ORDINANCE NO. _____

AN ORDINANCE to amend and reordain the Master Plan of the City of Alexandria, Virginia, by adopting and incorporating therein the amendment heretofore approved by city council to the Landmark/Van Dorn chapter of such master plan as Master Plan Amendment No. 2020-00009 and no other amendments, and to repeal all provisions of the said master plan as may be inconsistent with such amendment.

- a. Updates to text as provided below. *Deleted text is shown with a ~~strikethrough~~. Revised or additional text is underlined. The page numbers reference Chapter 10 of the Landmark/Van Dorn Corridor Plan which restarts its numbering sequence on page 1.*

Figure 1: Plan Area-wide Connectivity

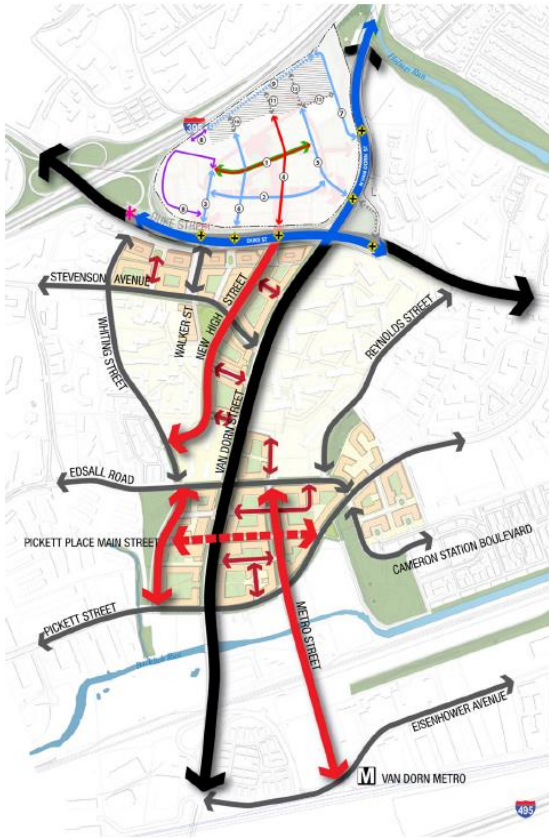
Approved 2021 Amendment

Figure 2: Framework Plan and Complete Street Typology

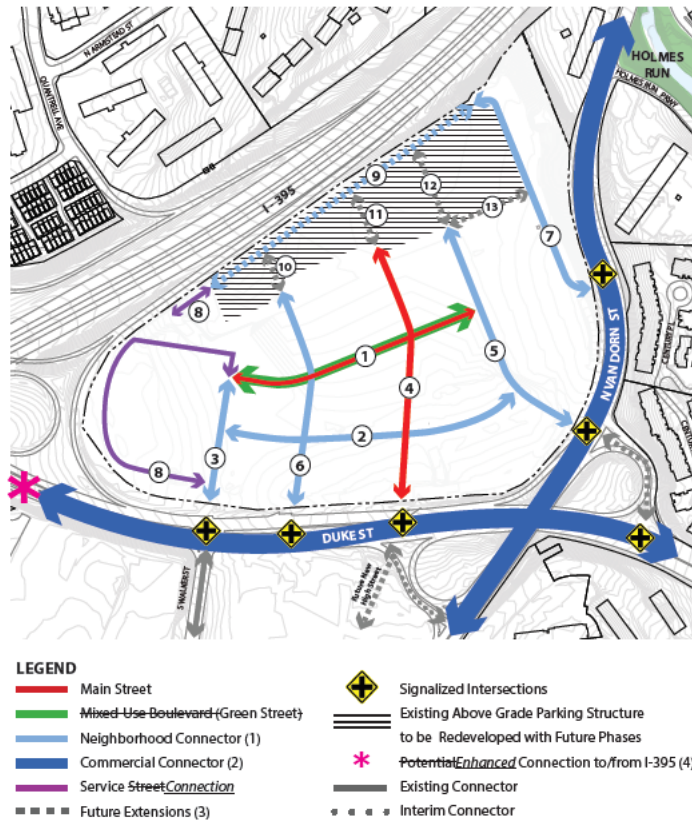
- The Plan recommends coordinating with the Virginia Department of Transportation (VDOT) to explore the opportunity for ~~a ramp an enhanced~~ connection with I-395 (Figure 2). In addition, the Plan recommends a potential pedestrian/bicycle bridge connection over I-395 to improve connectivity and access to the Landmark neighborhood as generally depicted in Figure 10.

- **10.1.13** Pursue Virginia Department of Transportation (VDOT) and all applicable agency approvals for ~~a ramp~~ an enhanced connection with I-395 as generally depicted in Figure 2 as part of a joint effort between the City and the property owner.

- Notes:
1. Framework Street 1 to be designed and constructed as a Neighborhood Connector but used in the interim as a Service Street.
 2. Improvements limited to property frontage.
 3. Future street extensions in the event that the above grade parking structure is redeveloped.
 4. Location of a potential enhanced connection is for illustrative purposes only. Final location will be in coordination with VDOT and the City.

Figure 9: Transit Hub

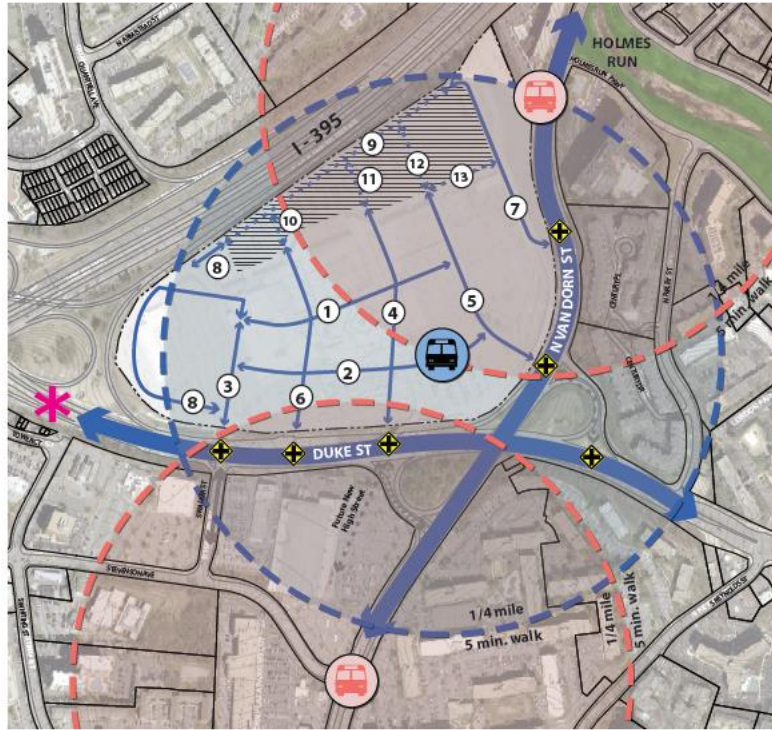
- 5. BRT will be provided on-street parallel to the curb on Framework Street ~~D 2~~ as generally depicted in Figure 9. Bus shelters will be provided in the Amenity Zone.

1. The proposed transit hub is for illustrative proposes only. Final location and coordination will be determined during the development review process.
2. Location of a potential enhanced connection is for illustrative proposes only. Final location will be in coordination with VDOT and the City.

Figure 12: Open Space
Approved 2021 Amendment

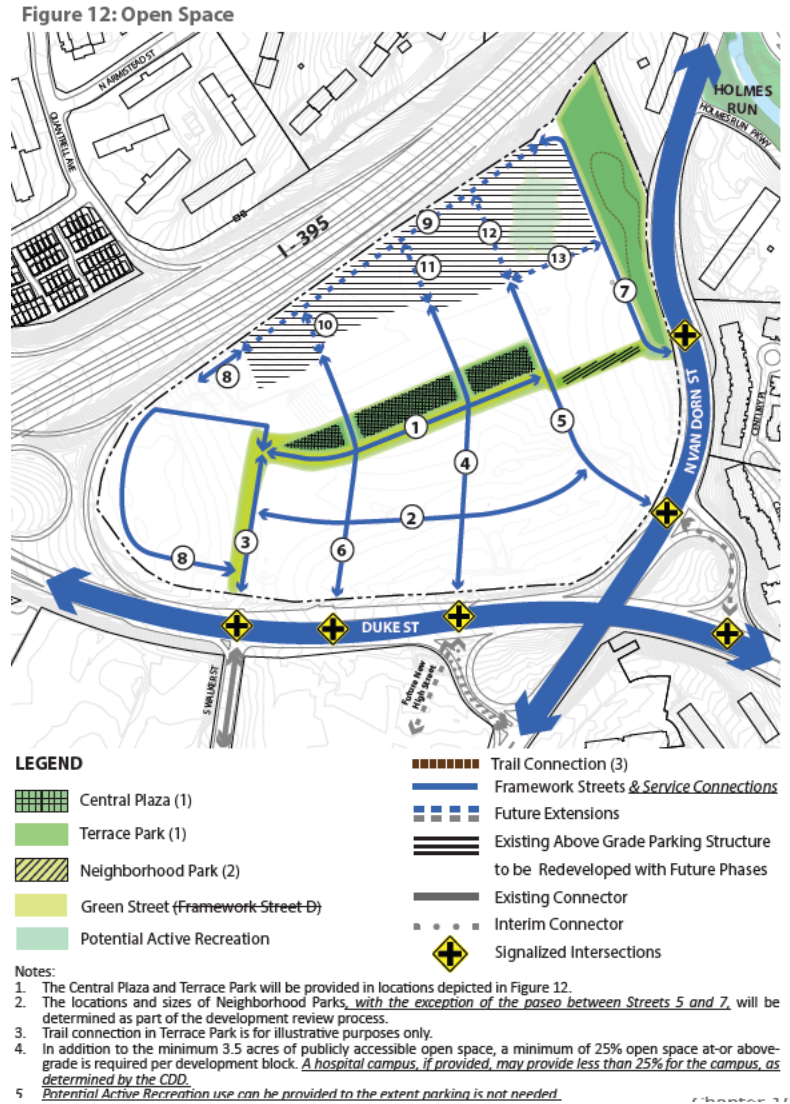
- At least 3.5 acres of publicly accessible at-grade open space will be provided in the approximate locations shown in Figure 12, with each space designed to be physically and visually connected by the neighborhood's green street, Framework Street ~~D 1~~. Each publicly accessible open space will be made accessible and usable to the public through dedication or provision of a perpetual public easement to the City. The minimum 3.5 acres of publicly accessible at-grade open space will consist of the following:

- **10.2.1** Provide a minimum of 3.5 acres of at-grade publicly accessible open space with passive and active elements for all ages and abilities as intended by the Plan that is physically and visually connected and accessible from the green street (Framework Street ~~D~~) and connects to surrounding publicly accessible open space as generally depicted in Figure 12. The following publicly accessible open spaces will be dedicated to the City or will include a perpetual public easement:

Figure 13: Land Use

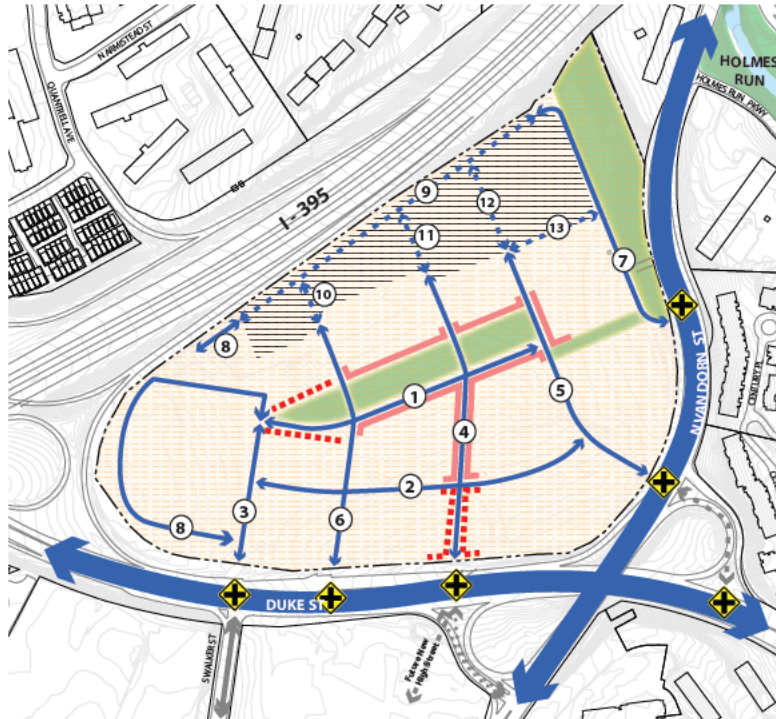
- **10.2.7** Of the ~~25%~~ open space per development block, publicly accessible ground level open space should be prioritized.
- **10.3.2** Provide required and preferred ground floor active/retail uses in the locations as generally depicted in Figure 13. Permitted uses in these locations must activate the adjacent street and/or open space. The specific uses permitted as retail will be established as part of the CDD approval(s).

- **10.3.3** In the required and preferred ground floor active/retail locations depicted in Figure 13, provide ground floor minimum ~~floor-to-ceiling~~ height of ~~17.5~~ 15 feet and minimum depth of 30 feet and building design that engages the public realm through use of transparent windows and building articulation.

Figure 15: Building Height
Approved 2021 Amendment

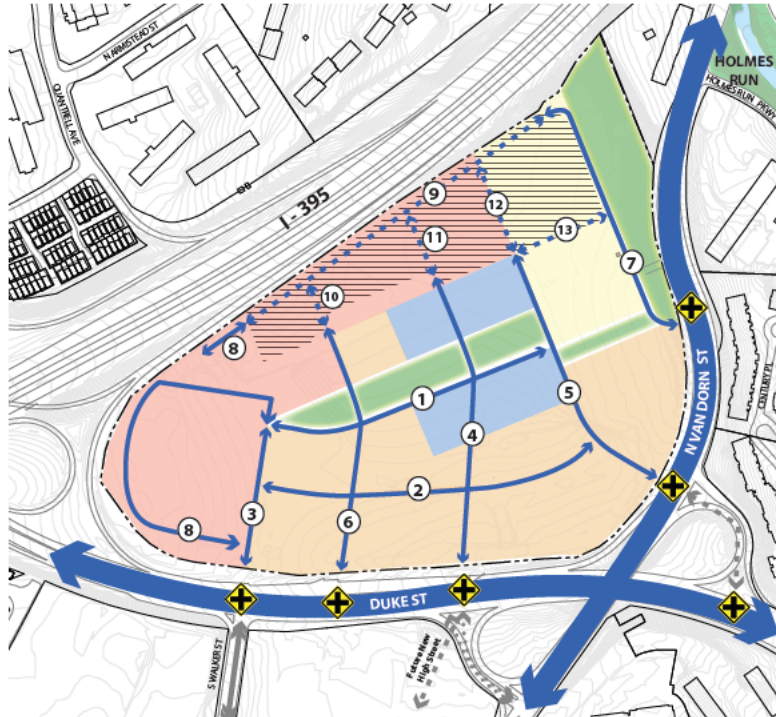
1. In Master Plan Amendment No. 2020-00009, the Planning Commission, having found that the public necessity, convenience, general welfare and good zoning practice so require, recommended approval to the City Council on June 24, 2021 of an amendment to the Landmark/Van Dorn Chapter of the Master Plan of the City of Alexandria through the Landmark Van Dorn Corridor Plan overlay to facilitate redevelopment of the Landmark site with a mix of uses and the Inova hospital campus including various amendments to the figures and text related to framework streets, open space, pedestrian and bicycle facilities, the connection to/from I-395, the existing parking garage, the transit hub, active retail streets and ground floor heights, streetwall, gateway and placemaking locations, screening of above grade parking structures, and building heights, which recommendation was approved by the City Council at public hearing on July 6, 2021;

Figure 16: Building Streetwall, Gateway and Placemaking Opportunities

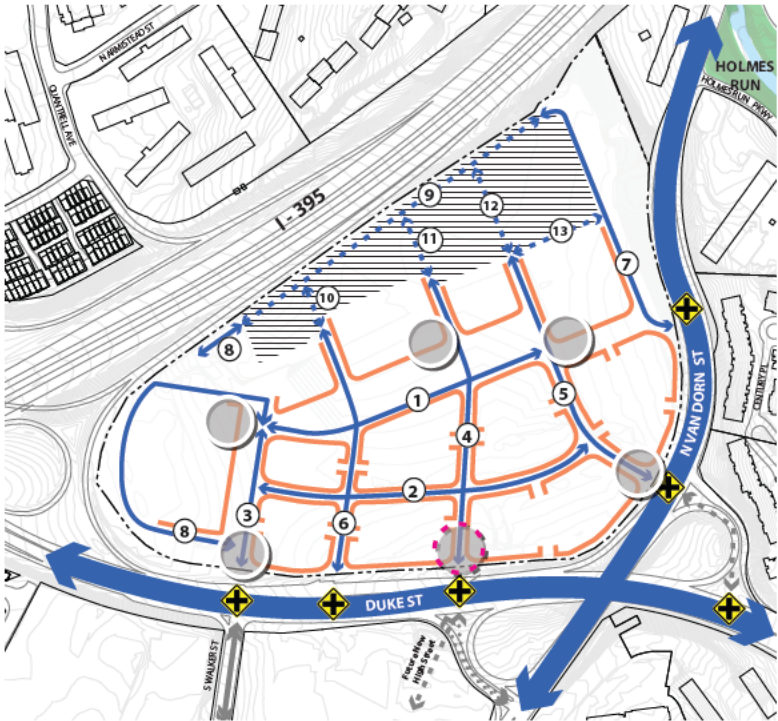
- 35 • Neighborhood-wide design standards for the public realm and buildings, including
36 elements such as lighting, signage/wayfinding, public art, setbacks, building massing,
37 articulation and other comparable features will be determined prior to submittal of the
38 first development special use permit. Design standards will be provided for buildings
39 taller than 100 feet to address sun and shade patterns across the neighborhood, and
40 emphasis will be given to the gateway at Framework Street ~~B~~ 4 and Duke Street to
41 visually denote this entrance to the retail core of the neighborhood (Figure 16).
42
43
44
45
46
47
48

- **10.5.6** Prepare general neighborhood-wide design standards for the public realm and buildings, including elements such as lighting, signage/wayfinding, public art, setbacks, building massing, articulation and other comparable features, that implement the vision of the Landmark neighborhood prior to submittal of the first development special use permit. Emphasize features at Framework Street ~~B4~~ and Duke Street as shown in Figure 16 to denote this entry to the retail core of the neighborhood.
